SIB 54 04 21

GAP IN FRONT SUNROOF SEAL

This Service Information Bulletin (Revision 1) replaces SI B51 04 21 **dated November 2021**.

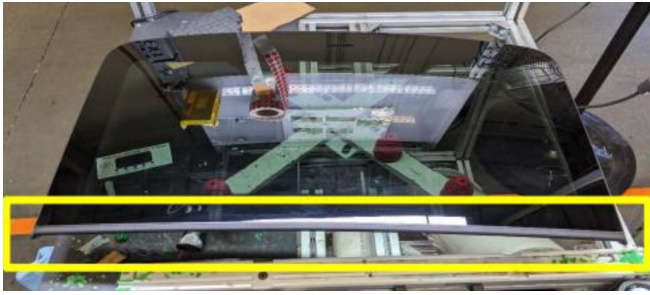
The front sunroof glass seal has shrunk, creating a gap which can cause wind noise or excess water entry.

1. Remove the front sunroof glass seal (mounted to the glass panel) following repair instructions **REP 54 13 052 "Replace seal on front glass slide/tilt sunroof panel"**.

2. In addition, bond the new seal to the glass panel at the ends using adhesive P/N 07 58 9 062 157. Apply 3 small spots of adhesive at each end.

3. Reinstall the seal following repair
